American Association of
State Highway and
Transportation Officials

Recently, we were made aware of some technical revisions made to the 4th Edition of *A Policy on Geometric Design of Highways and Streets, 2001,* or the *"Green Book"* as it is commonly called.

Revisions posted after the July 2002 meeting of the Task Force on Geometric Design
(to be incorporated into the first printing of *A Policy on Geometric Design of Highways and Streets,* 4th Edition, 2001)

Exhibit 9-87. Above Minimum Design of Median Openings (Typical Bullet-Nose Ends)

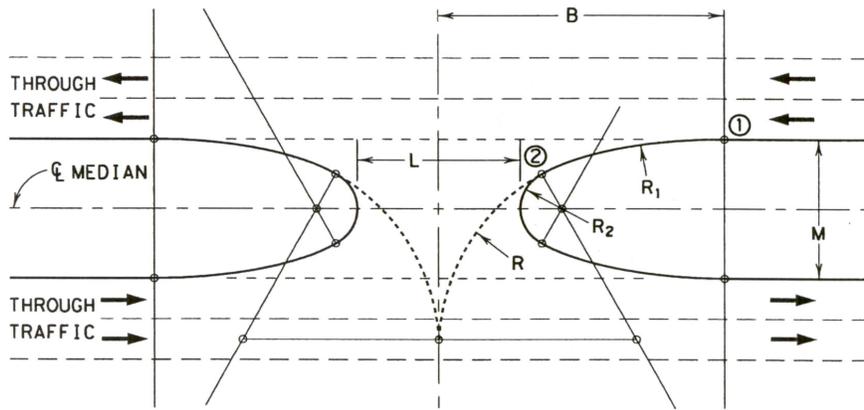
Page	Exhibit	Existing Text	Correction Made
706		Exhibit 9-84 is referenced in the 12[th] line (last) of the 6[th] paragraph on the page.	Changed the exhibit referenced to Exhibit 9-87.
708	9-87	Five items in this exhibit are incorrect: (1) Point 1 is misplaced, (2) the dimension b is lower case, (3) a dimension for R_1 is incorrect, (4) several values for B are incorrect, and (5) the dimension line is missing for M.	Replaced Exhibit 9-87. See attached. Changed "b" to "B" in last sentence of 1[st] paragraph.
725	9-97	The note in the legend block refers to Exhibits 9-74, 9-77, 9-79, and 9-80.	Revised the note to read "Refer to Exhibits 9-77 through 9-83."
737		The last paragraph on the page refers to Exhibit 9-103 in the 3[rd] line.	Changed the reference to Exhibit 9-104.
738		In the Metric section of the equation table, the equation for d_H reads: $d_H = AV_v t + D + d_e$	Replaced the equation for d_H with: $$d_H = AV_v t + \frac{BV_v^2}{a} + D + d_e$$

Exhibit 10-60. Typical Gore Details

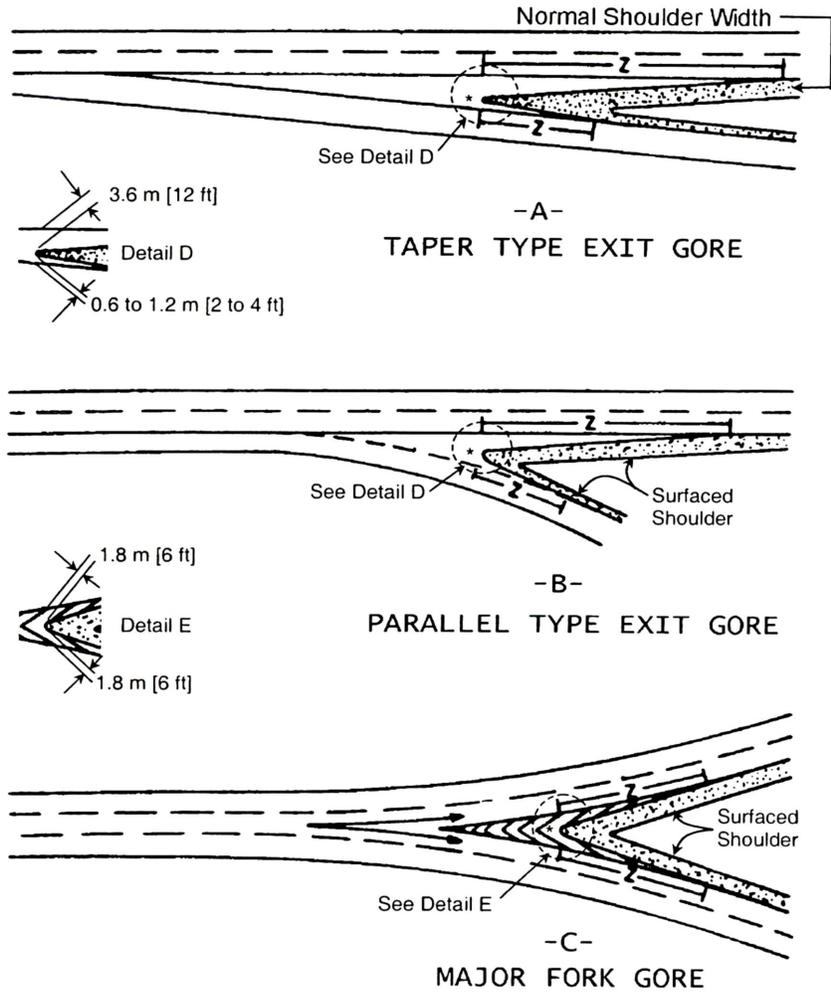
742	9-105	The equations for Metric and US Customary at the top of the exhibit contain an error.	Replaced the equations at the top of the exhibit with equations shown in the equation box on page 740.
838	10-60	Exhibit 10-60 is incorrect.	Replaced Exhibit 10-60. See attached.
839		In the 2[nd] paragraph on the page, the 2[nd] line references Exhibit 10-61.	Revised the reference to Exhibit 10-60.

Exhibit 10-72. Exit Ramps—Single Lane

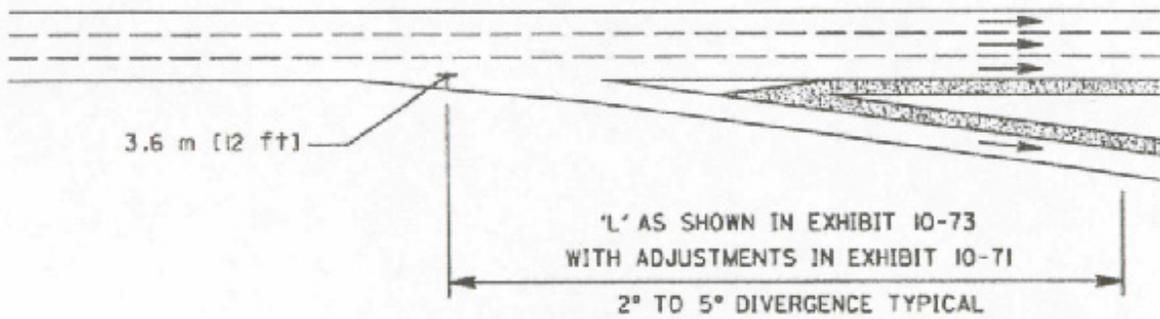
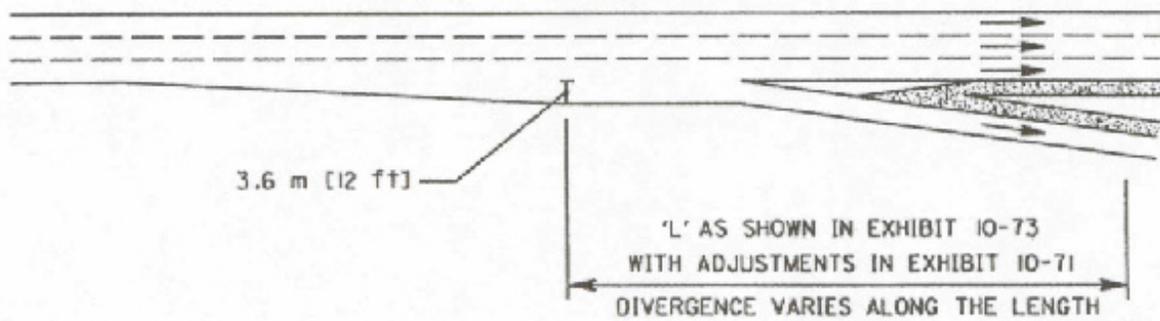
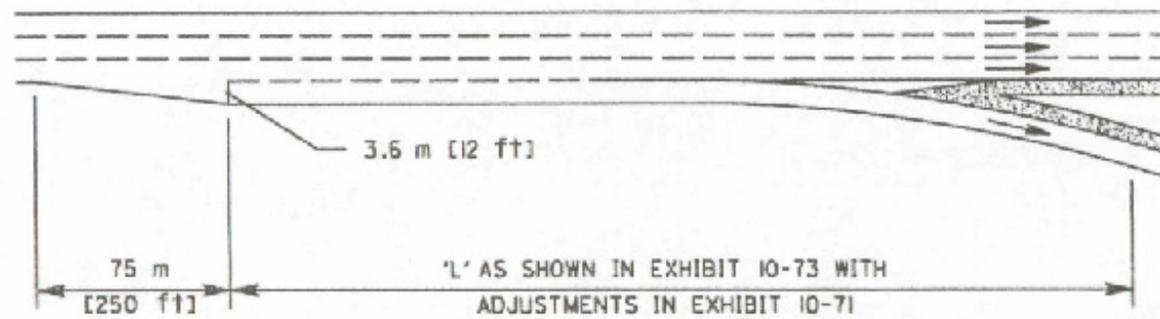
843	10-67	In the Metric section, the heading for the Case I column reads "with provision for passing a stalled vehicle."	Revised Case I to read "no provision for passing a stalled vehicle" so that it matches the US Customary heading.
852	10-71	In the metric section, under the column All Speeds, the second grouping of speeds reads "3 to 4% downgrade."	Revised the heading of the 2nd group of speeds to read "5 to 6% downgrade."
854	10-72A	The dimension line for 3.6 m [12 ft] should be shown from the right edge of the ramp to the projected right edge of the right freeway lane upstream from the ramp (similar to the way it is shown in Exhibit 10-72B).	Revised figure for Exhibit 10-72A. See attached.

Exhibit 2-9. Minimum Turning Path for Large School Bus (S-BUS-12 [S-BUS-40])
Design Vehicle

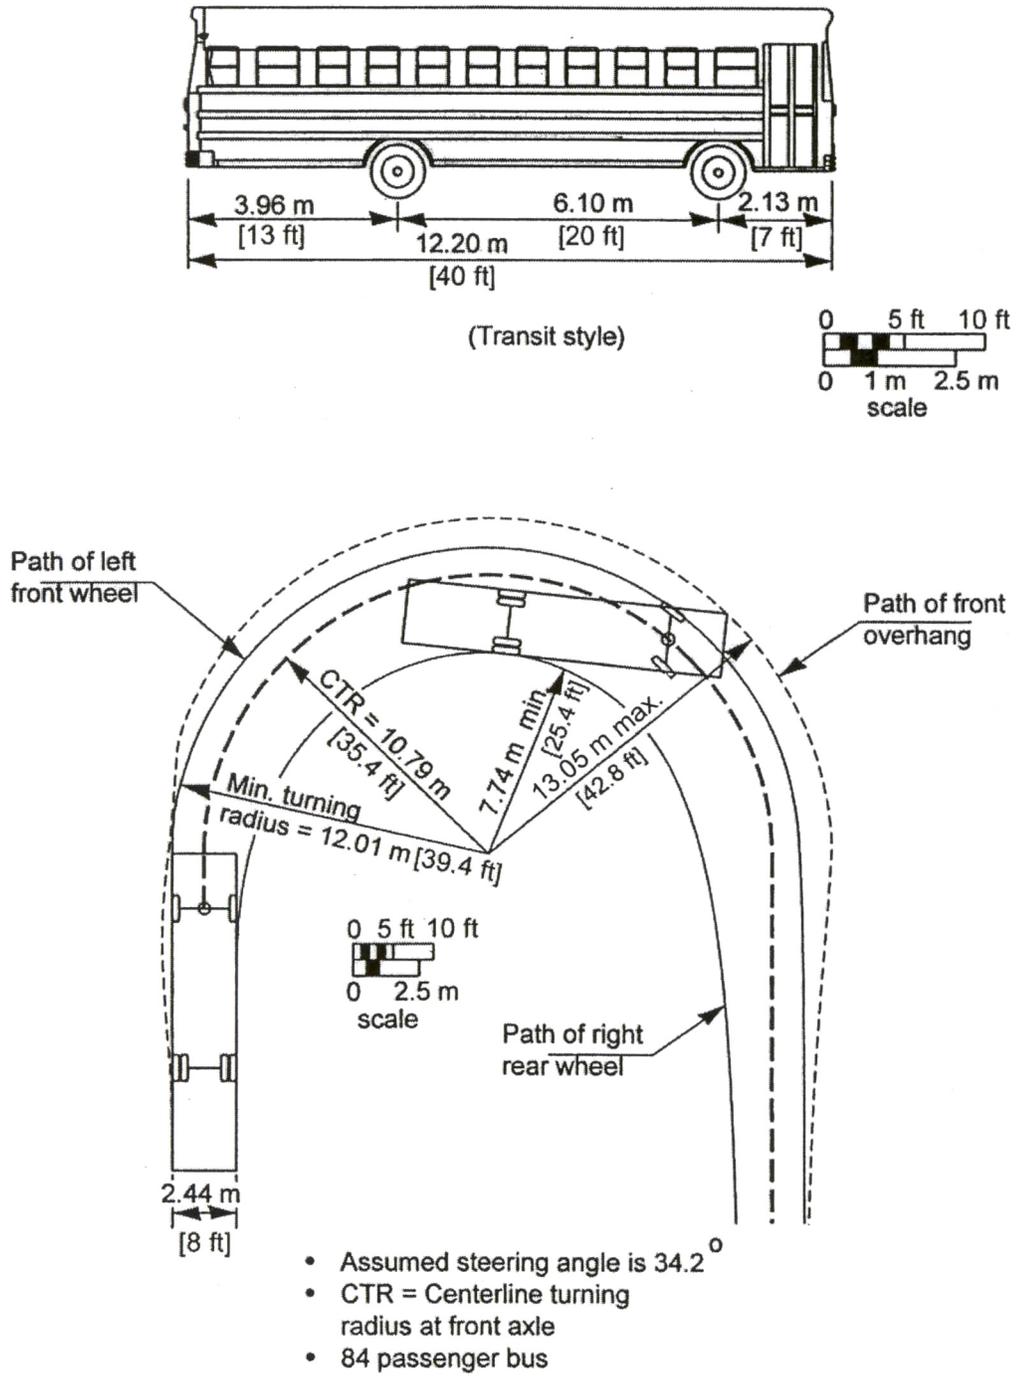
Page	Exhibit	Existing Text	Correction Made
16	2-1 (Metric)	Footnotes in Exhibit 2-1 are out of order.	Reordered footnotes for Exhibit 2-1. See attached.
17	2-1 (US)	Footnotes in Exhibit 2-1 are out of order.	Reordered footnotes for Exhibit 2-1. See attached.
27	2-9	The Path of the Front Overhang indicates radius of "13.35 m max. [42.8 ft]."	Revised the radius to read "13.05 m max. [42.8 ft]." See attached.
34	2-16	Wheelbase of vehicle reads "19.42 m [65 ft]."	Revised the Wheelbase to read "19.81 m [65 ft]." See attached.
35	2-17	The overall length of the design vehicle is shown as 22.05 m [72.33 ft].	Revised overall length of the design vehicle to read "22.4 m [73.3 ft]." See attached.
58		4th paragraph, 8th line	Replaced "double" with "significantly higher than."
66		2nd full paragraph, 7th and 8th line	Changed "four" to "five" in line 7 and replaced "and" with a comma (,) in the 8th line.
250		3rd full paragraph, 13th line	Deleted "depending on the weight/power ratio of the appropriate truck." Added the new sentence, "Different curves would apply for trucks with other than a weight/power ratio of 120 kg/kW [200 lb/hp]."

**Exhibit 9-40. Details of Divisional Island Design**

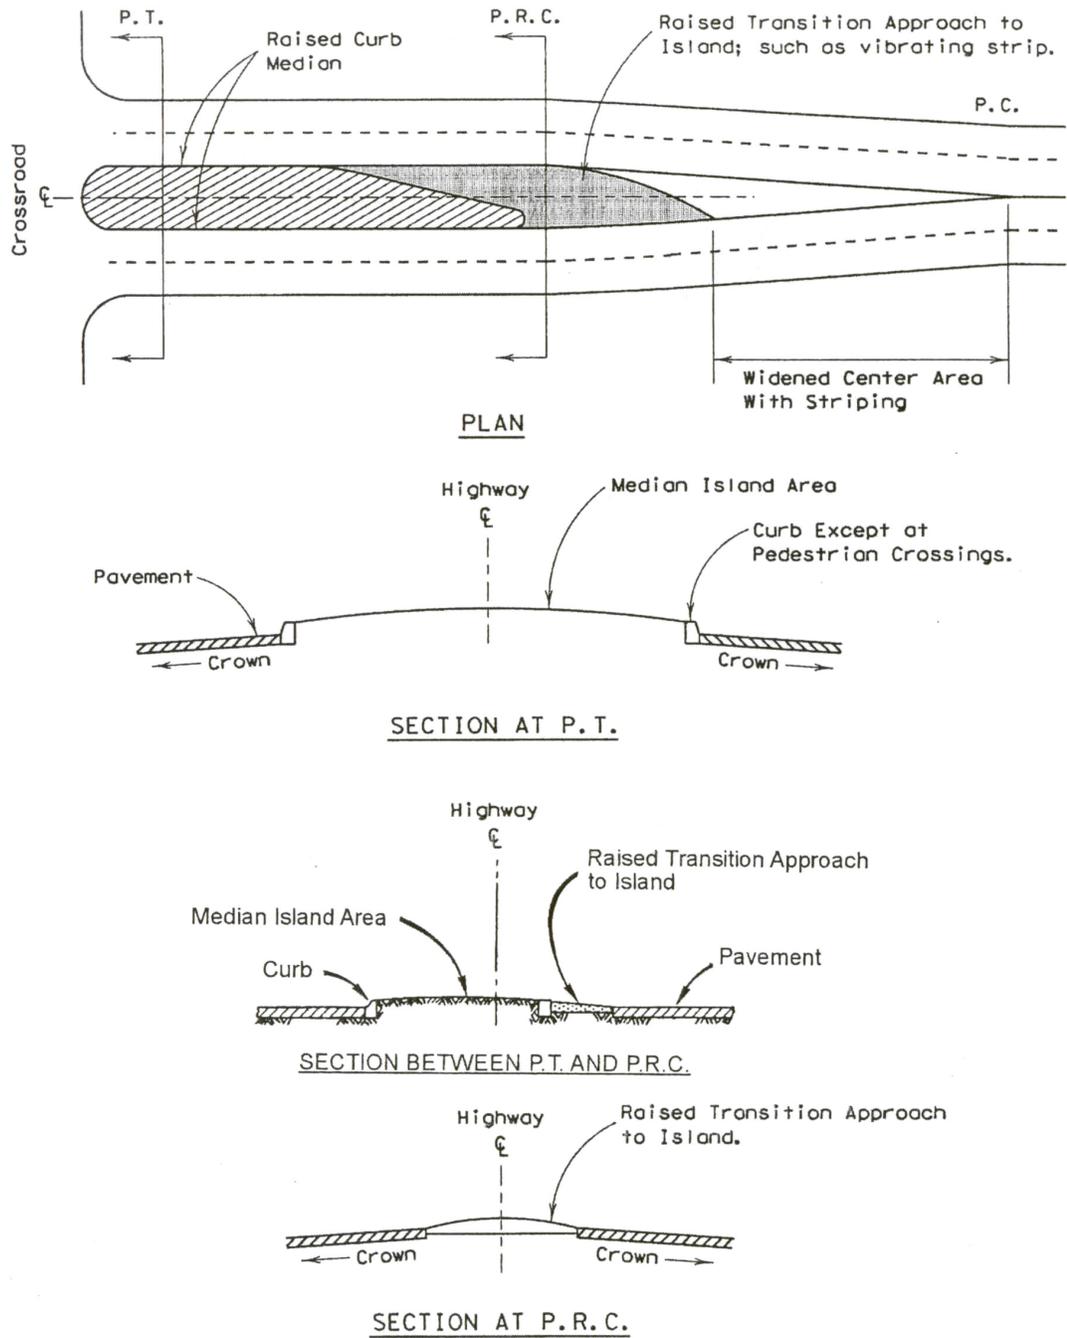
Page	Exhibit	Existing Text	Correction Made
637	9-40	Section Between P. T. and P.R.C. is incorrect.	Replaced illustration for Section Between P. T. and P.R.C. See attached.
643		Exhibit 9-43 is referenced in the 4[th] line of the 2[nd] full paragraph on the page.	Changed the exhibit referenced to Exhibits 9-43B and 9-43C.
696	9-76	The path for the WB-62 vehicle is not labeled for US Customary section.	Labeled the line in both Parts A and B of Exhibit 9-76 consisting of alternating long and short dashes as WB-62. See attached.
725	9-97	2[nd] Metric drawing does not contain a caption.	Added a caption – 1[st] line: "M = 5.4 m and over – Elongated taper"; 2[nd] line: "-B-". See attached.

Exhibit 3-11. Comparison of Side Friction Factors Assumed for Design of Different Types of Facilities

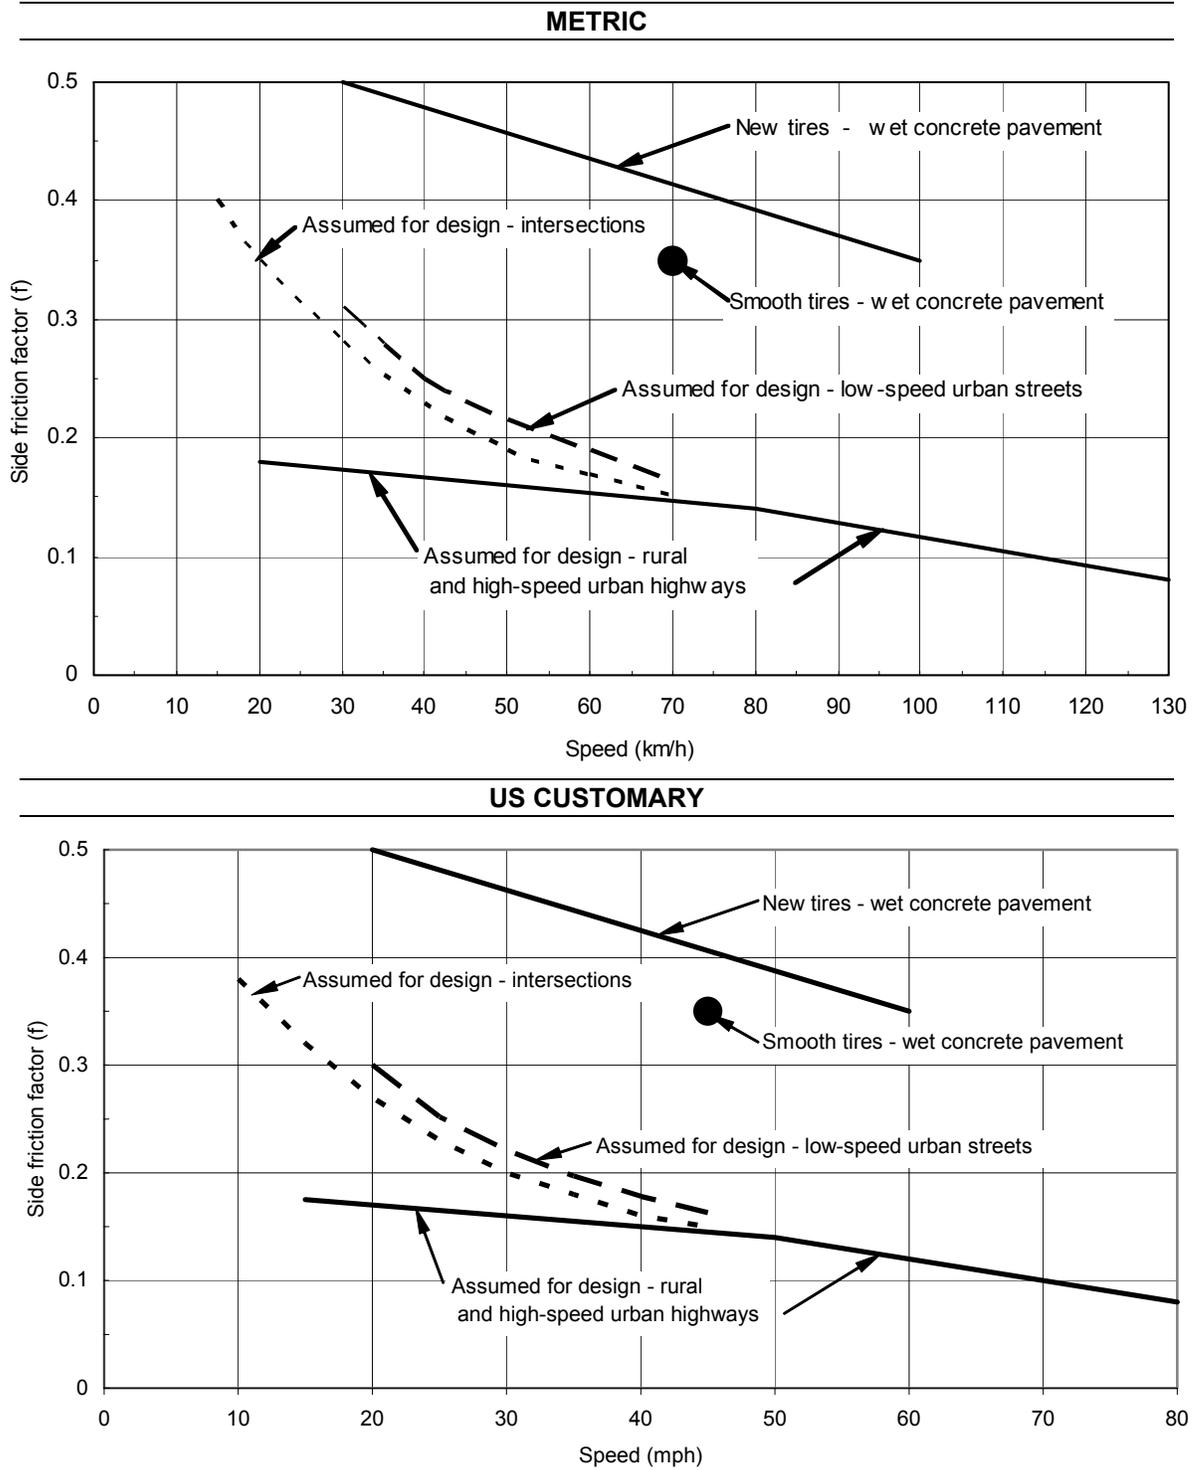
Page	Exhibit	Existing Text	Correction Made
137	3-11	The line labeled "Assumed for design— rural and high-speed urban highways" was plotted with incorrect values.	Revised Exhibit 3-11. See attached.
188		The sentence that begins on the 4th line of the 1st paragraph reads "For an approximate guide, however, the minimum vertical curve length in meters [feet] can be used as numerically equal to the design speed in kilometers per hour [equal to the design speed in miles per hour]."	Revised the sentence to read "For an approximate guide, however, the minimum vertical curve length in meters [feet] can be used as numerically equal to 0.2 times the design speed in kilometers per hour [equal to the design speed in miles per hour]."
400		In the section on Alleys, the last sentence of 3rd paragraph reads "less than 2 percent."	Revised the value to 0.2 percent.
589– 590	9-19	In both the Metric and the US Customary tables, the tapers are missing for the first three vehicles for the 105- and 120-degree turns.	Revised the tables to show that the tapers for 105-degree turns should be 8:1, 10:1, and 10:1 for P, SU, and WB-12 (WB-40), respectively, and that the tapers for 120-degree turns should be 10:1, 10:1, and 8:1 for P, SU, and WB-12 (WB-40), respectively. See attached.

Exhibit 9-103. Case A: Moving Vehicle to Safely Cross or Stop at Railroad Crossing

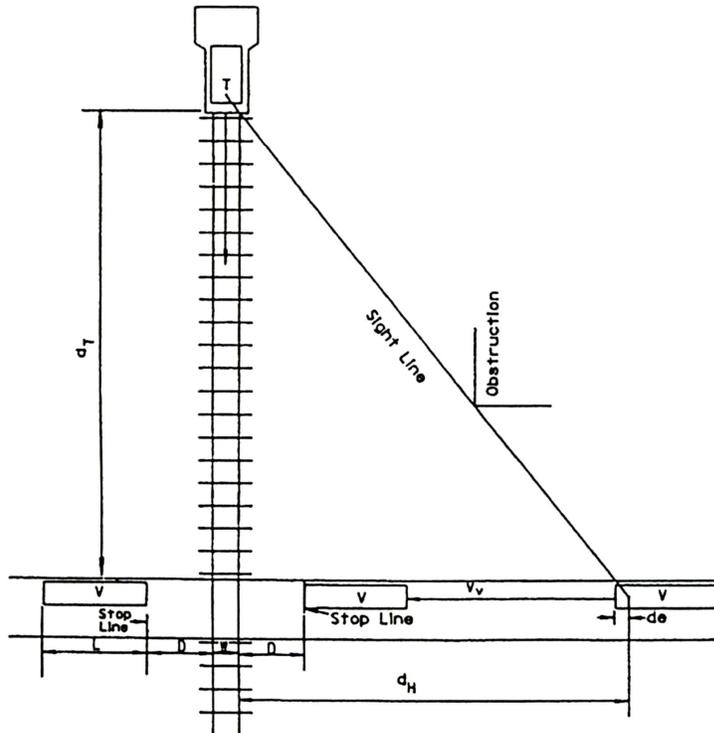
739	9-103	The definition of terms under the formulas contained errors and omissions.	The formulas at the top of Exhibit 9-103 should be identical to those on the previous page. Replaced all definitions of terms under the formulas with the definition of terms from page 738. See attached.
834		The paragraph numbered 3 refers to Exhibit 9-43.	Revised the reference to Exhibit 9-44.
842		The second bullet contained errors in the 6th and 8th lines.	Revised "6.6 m [22 ft]" to "6.4 m [21 ft] in the 6th line. Revised "4.8 m [16 ft]" to "4.8 m [15 ft]" in the 8th line.
